“Force-From-Below” Theory Inconsistent With Measured Hook Load

Figure 19 Recreation of Stress Engineering’s Effective Tension Graph

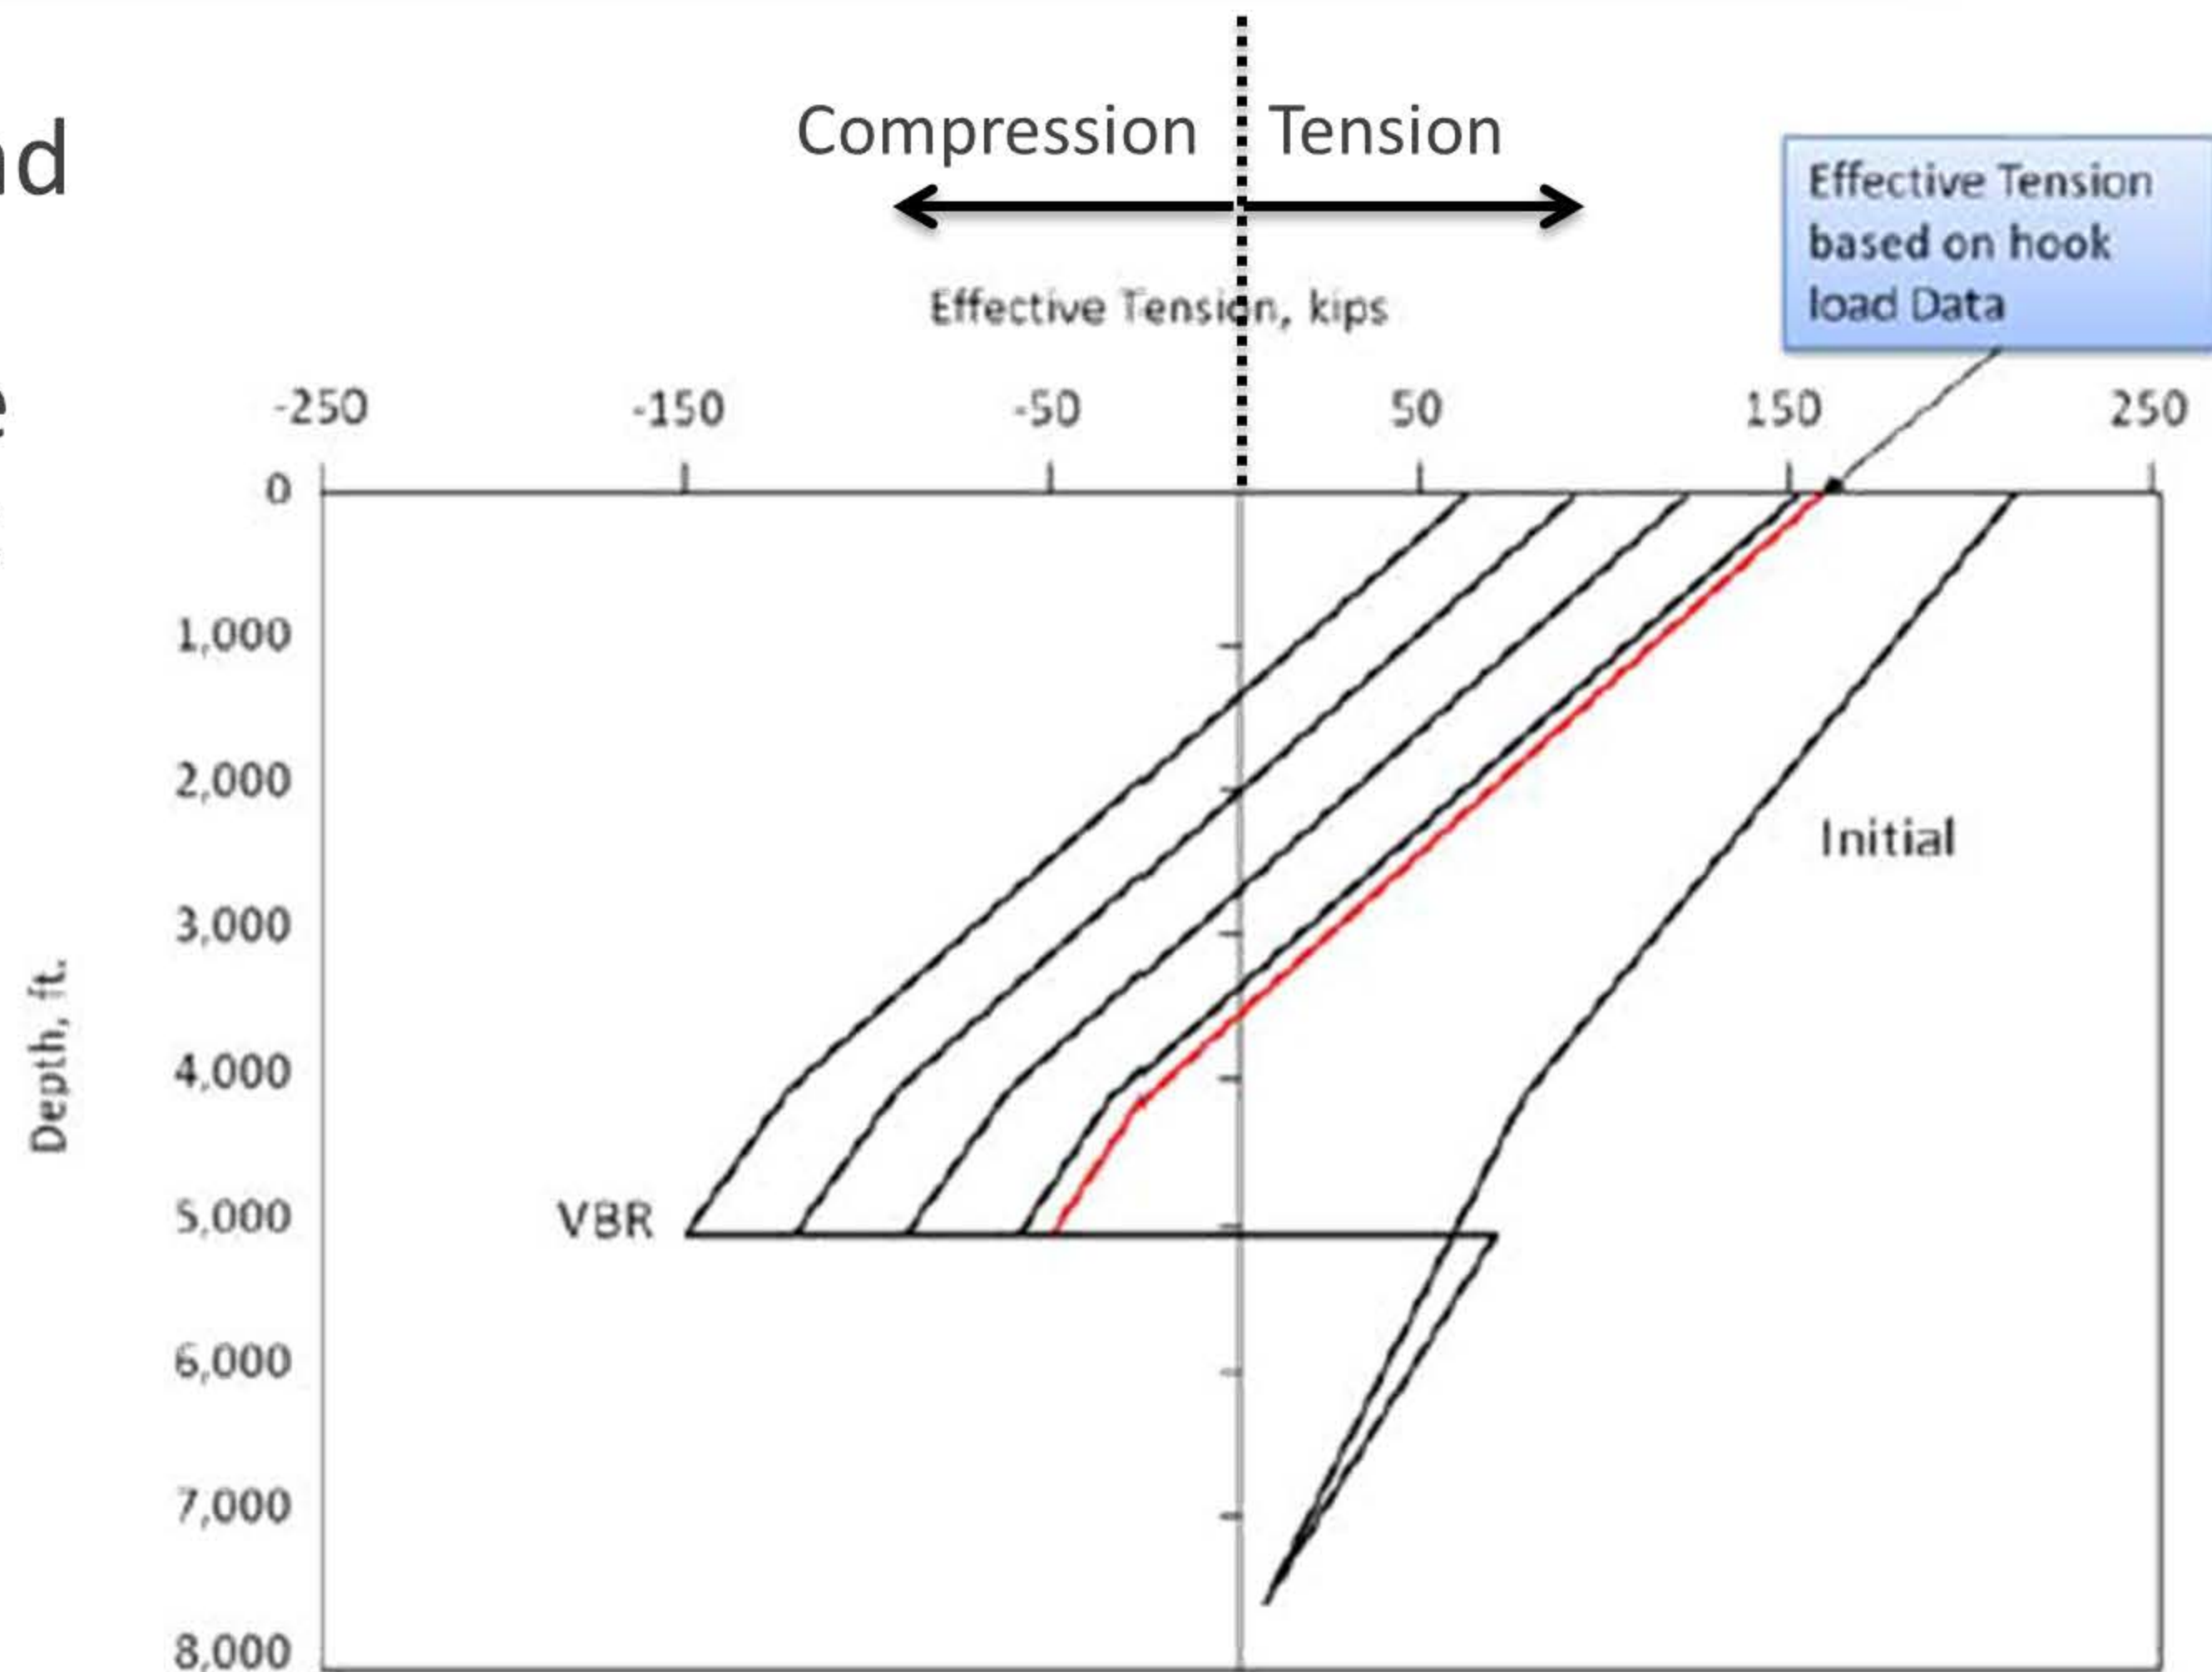
- When the hook load is applied, Stress Engineering’s force calculations do not have enough compression to buckle drill pipe
